CPED STAFF REPORT

CPC Agenda Item #6
 October 14, 2014
 BZZ-6763

Property Location: 2812 University Avenue SE
Project Name: Hampton Inn and Suites - University
Prepared By: [Mei-Ling Anderson](#), City Planner, (612) 673.5342
Applicant: Dave Barnhart and Jeff Barnhart
Project Contact: Daniel L. Pellinen, Tushie Montgomery Architects
Request: To allow a new, five-story hotel with 117 rooms.
Required Applications:

213091A
SITE PLAN
 1.2

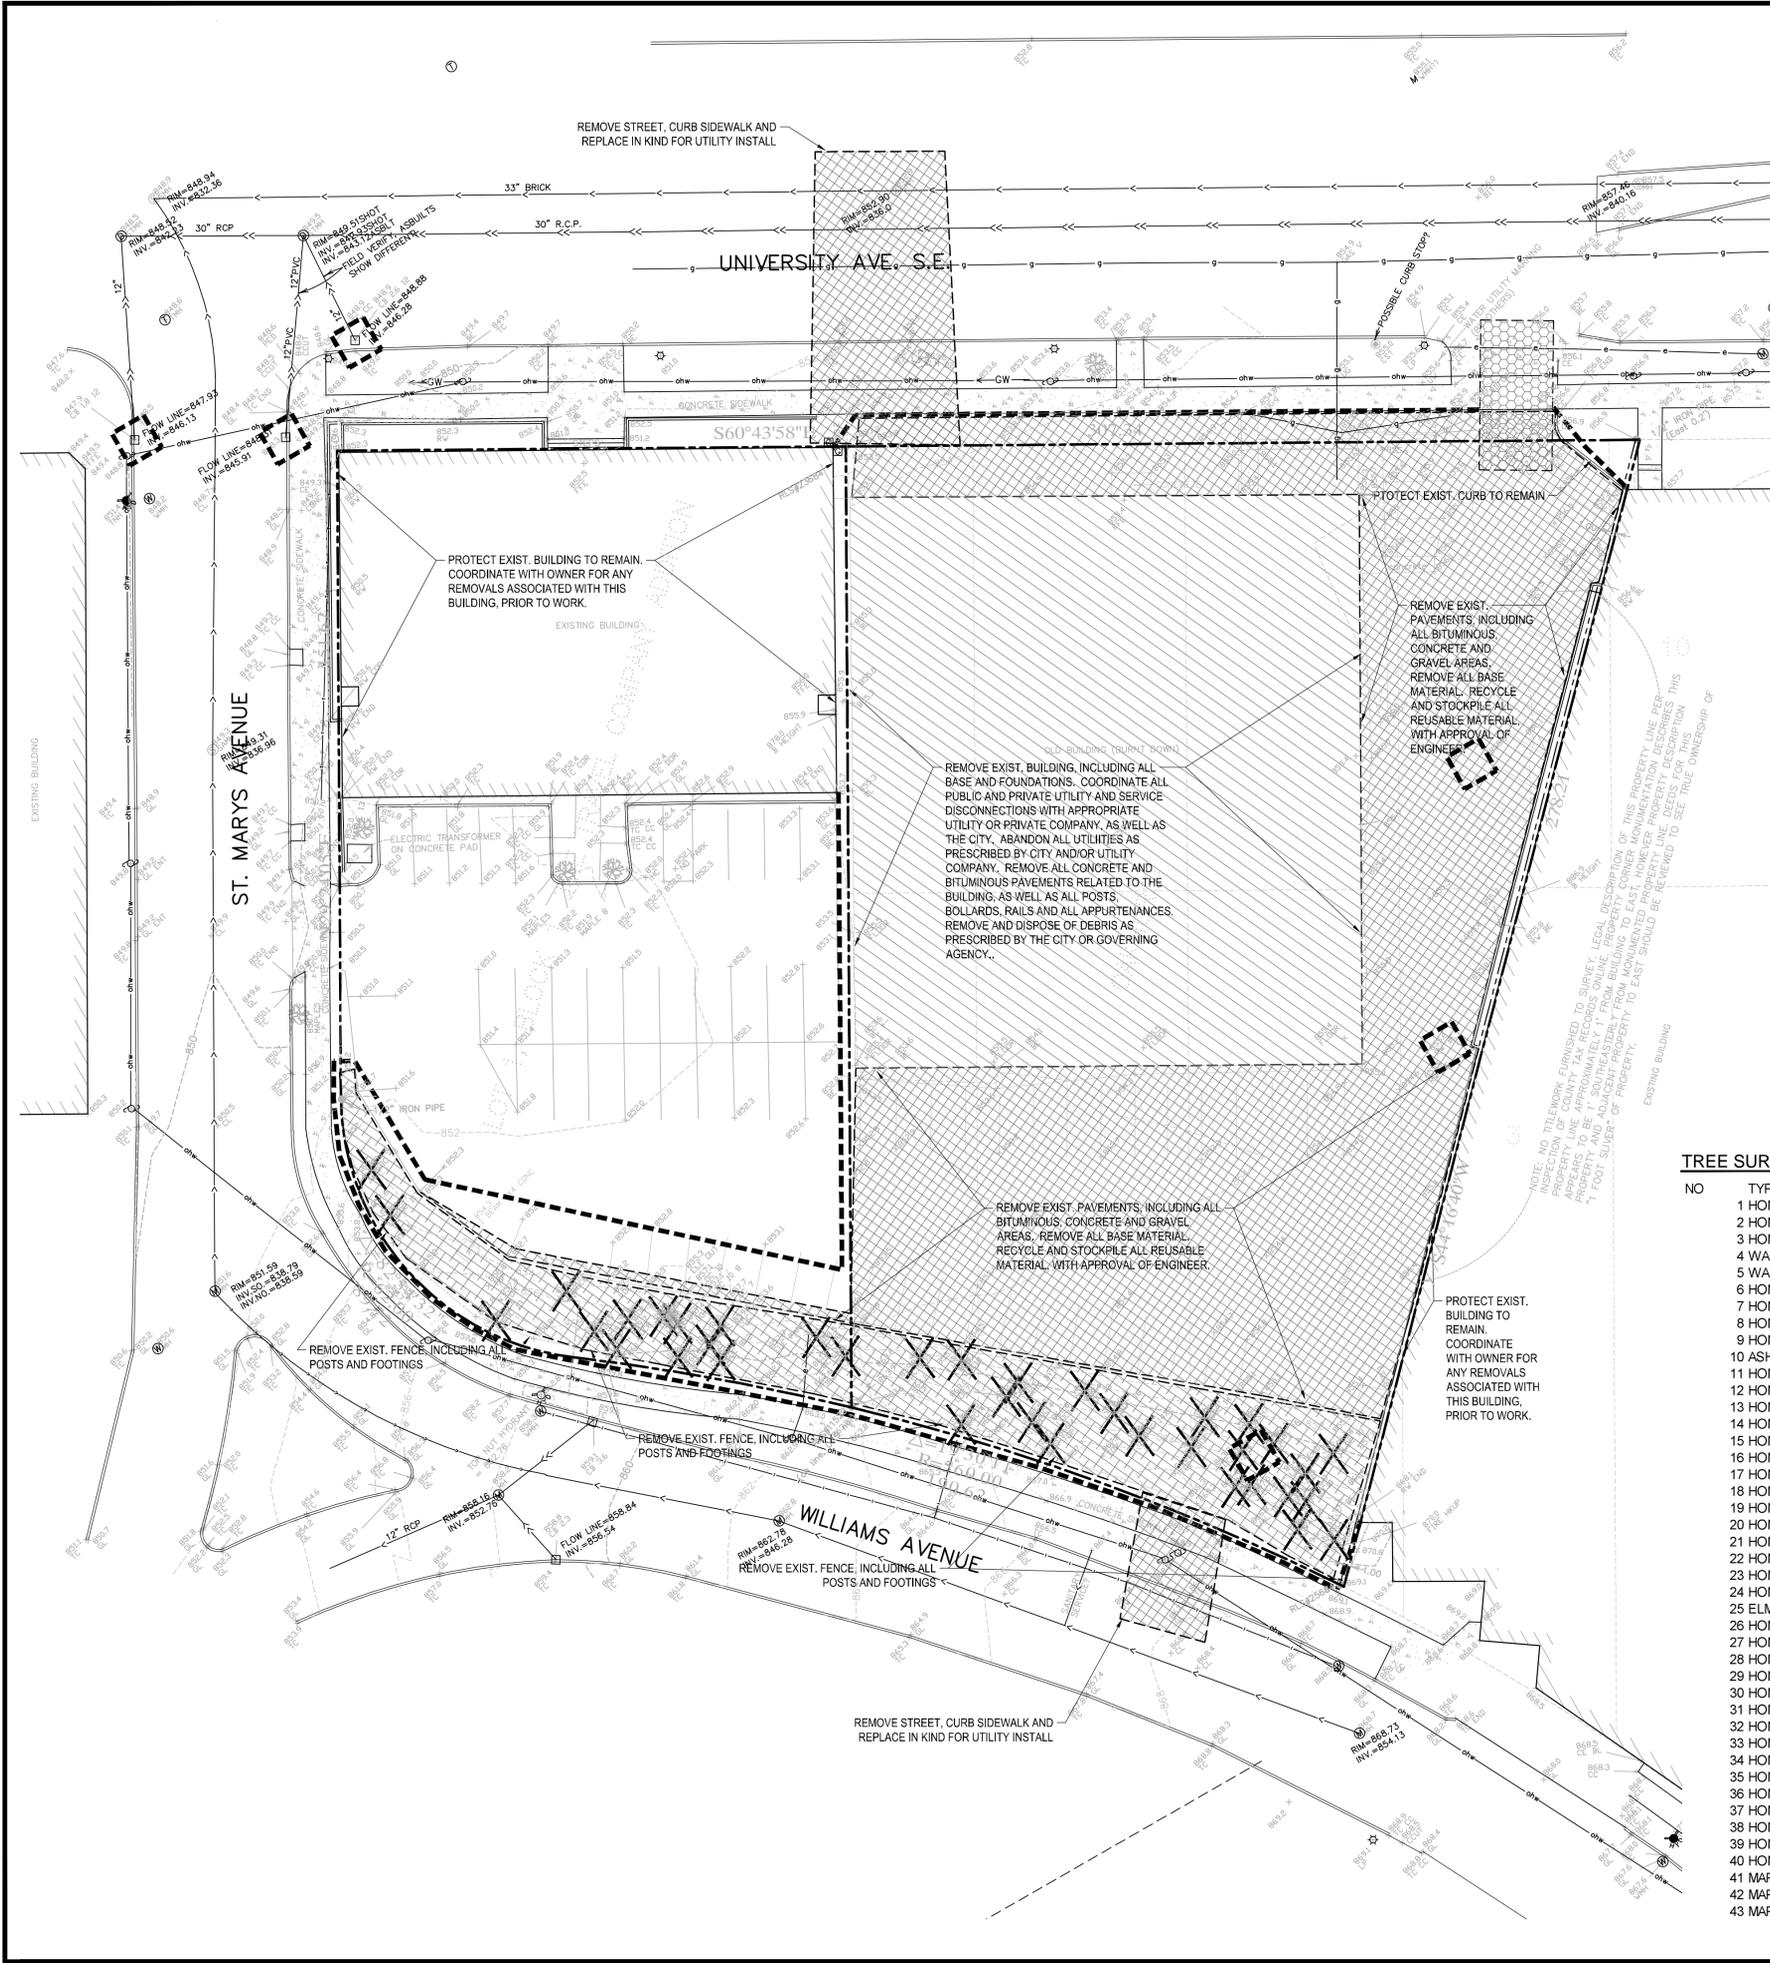
- All areas not occupied by buildings, parking, and loading areas contain landscaping.
- The site contains a surface parking area with 37 spaces. The parking lot frontage along the south property line (Williams Avenue SE) is required to contain a landscaped yard of at least seven feet in width. The applicant is proposing to provide a landscaped yard that would range between zero and 18 feet in this location. Because the landscaped yard does not total seven feet or more in width along the south parking lot frontage, alternative compliance is requested.

- The zoning code requires that a six-foot screen that is at least 95 percent opaque be provided between parking areas and adjacent residential uses, and a three foot tall screen that is 60 percent opaque be located between the parking area and an adjacent street. A six-foot screen is required between the parking area and the residential uses to the south. The applicant is proposing a six-foot tall decorative aluminum fence along the entire length of the south property line, which would sit atop a retaining wall. The combination of the change in topography between the parking area and the public street, the landscape materials in the required yard, and the fence would create an effective screen between the parking area and adjacent residential uses to the south.

- Surface parking areas are required to have no less than one tree per each 25 linear feet of parking or loading area frontage. This requirement applies to the south parking lot frontage, which would be required to have five canopy trees and three are provided. Alternative compliance is requested for the linear tree requirement. Staff finds that it would be practical to grant alternative compliance for this standard, as the grade change and lack of a landscaped yard on the Williams Avenue SE frontage would make it difficult to add additional canopy trees in this location.

1. Approval of the final site, elevation, landscaping, and lighting plans by CPED staff.
2. All site improvements shall be completed by November 14, 2016, unless extended by the zoning administrator, or the permit may be revoked for non-compliance.
3. All signs are expected to comply with Chapter 541 of the zoning code. All signage requires a separate permit from CPED.
4. The applicant shall label the proposed mechanical equipment and screening materials to demonstrate compliance with the screening requirements of Chapter 535 of the zoning code.
5. The applicant shall provide no less two additional canopy tress on-site, for a total of five, and no less than 177 square feet of additional landscaped area.

4 BLADE SIGN
 SCALE 1/4" = 1'-0"

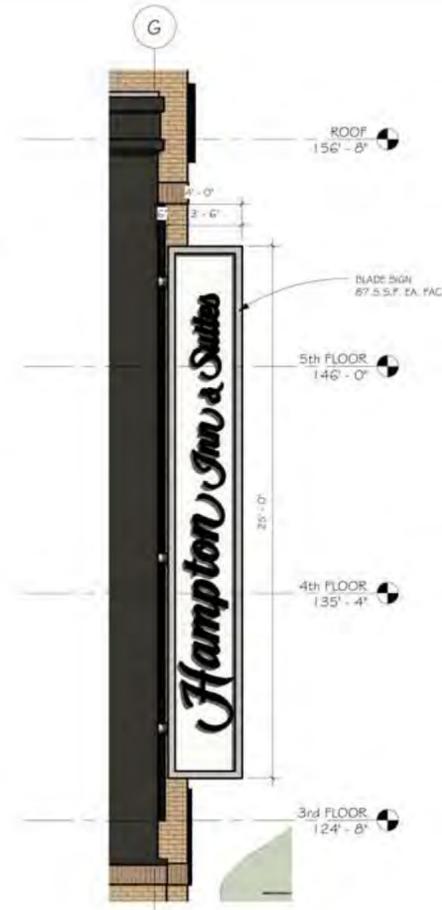
The applicant is seeking a variance to increase the maximum permitted area of a projecting sign from 48 to 87.5 square feet. The regulations governing on-premise signs were established to allow effective signage appropriate to the planned character of each zoning district, to promote an attractive environment by minimizing visual clutter and confusion, to minimize adverse effects on nearby properties, and to protect the public health, safety, and welfare. Staff believes that the proposed projecting sign of 3 feet-6 inches by 25 feet, and 50 feet 8 inches above grade, will diminish the pedestrian experience in the area by increasing visual clutter. The subject property allows for a total signage allocation of 193.5 square feet in area along University Avenue SE, and the applicant is proposing one other sign for the site. Staff finds that a projecting sign of 48 square feet on each side, as allowed by the ordinance, would allow for effective identification.

The proposed projecting sign is proposed along University Avenue SE. The regulations governing on-premise signs were established to allow effective signage appropriate to the planned character of each zoning district, to promote an attractive environment by minimizing visual clutter and confusion, to minimize adverse effects on nearby property, and to protect the public health, safety, and welfare. Staff finds that the proposed area of the projecting sign would lead to sign clutter. Signage is already allowed on three sides of the building. Staff believes that the proposed sign would be in keeping with the purpose of the zoning district if it were designed to not exceed 48 square feet in area on each side.

The Department of Community Planning and Economic Development recommends that the City Planning Commission adopt the above findings and **deny** the application for a variance to increase the maximum area of a projecting sign from 48 square feet to 87.5 square feet at the property located at 2812 University Avenue Southeast, subject to the following conditions:

213091A
SHADOW STUDY
1.6

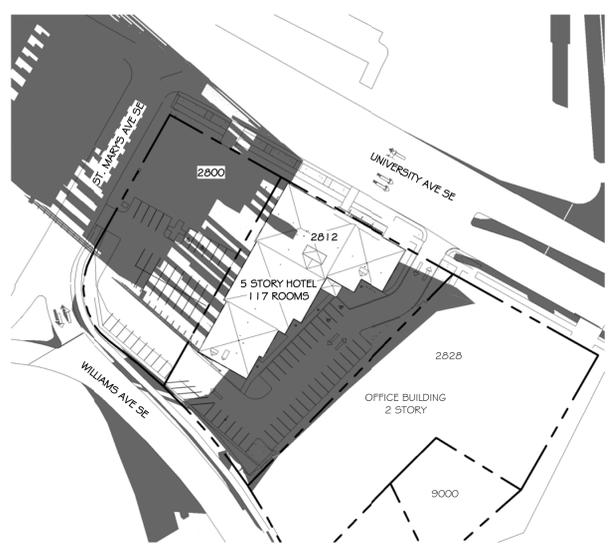
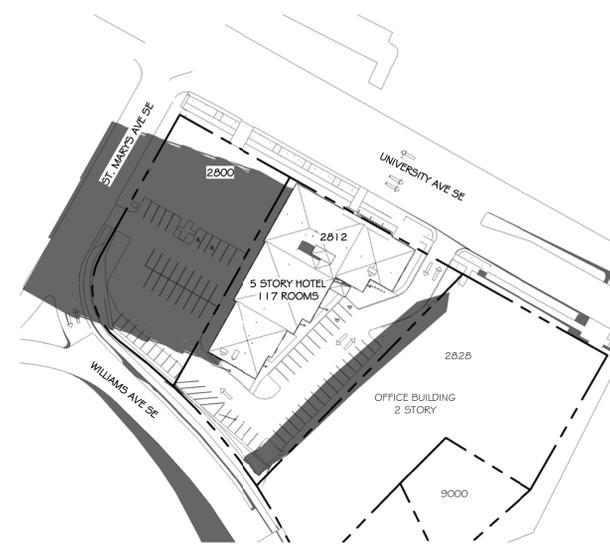
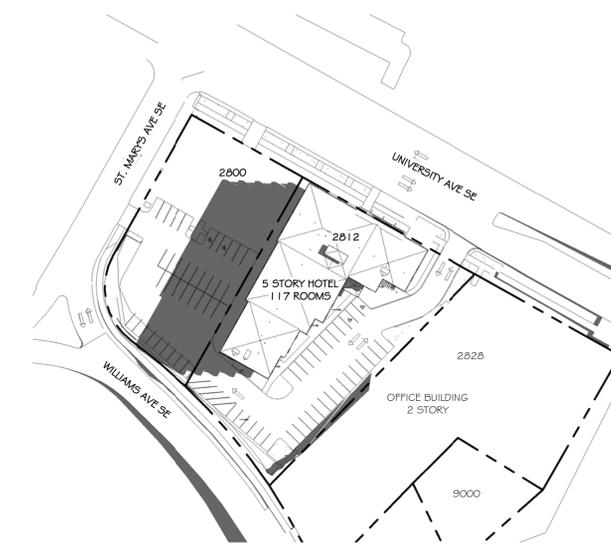
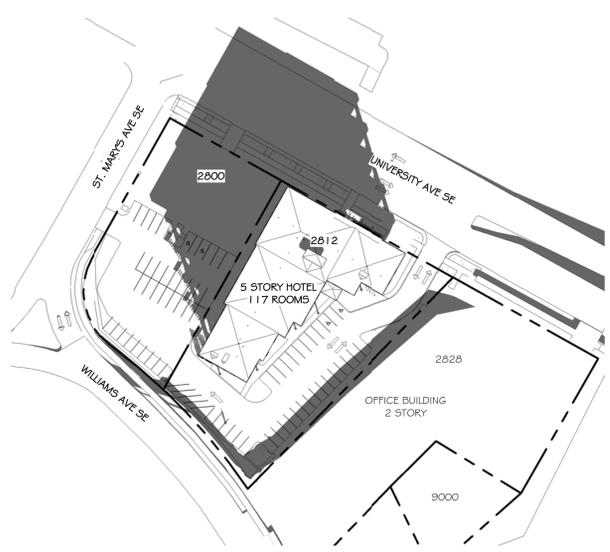
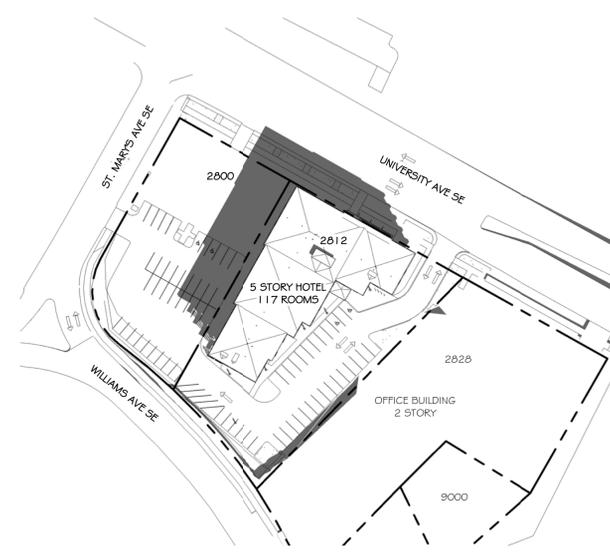
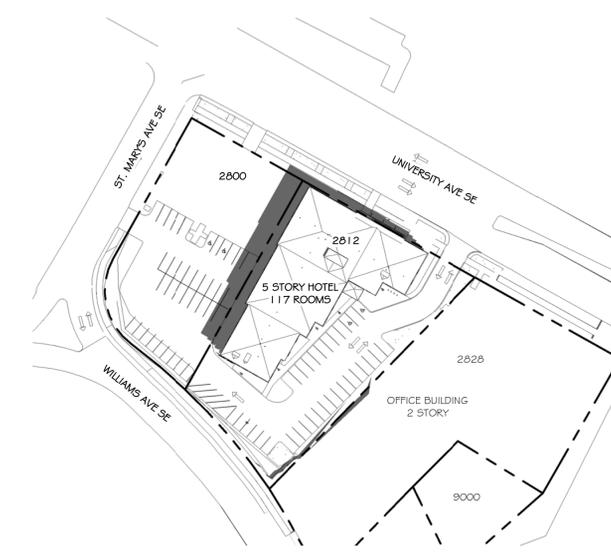
The site in question is located approximately ten feet below the grade of the residential properties on the opposite side of Williams Avenue SE. Approving the conditional use permit for height would not result in substantial shadowing effects on nearby residential properties.
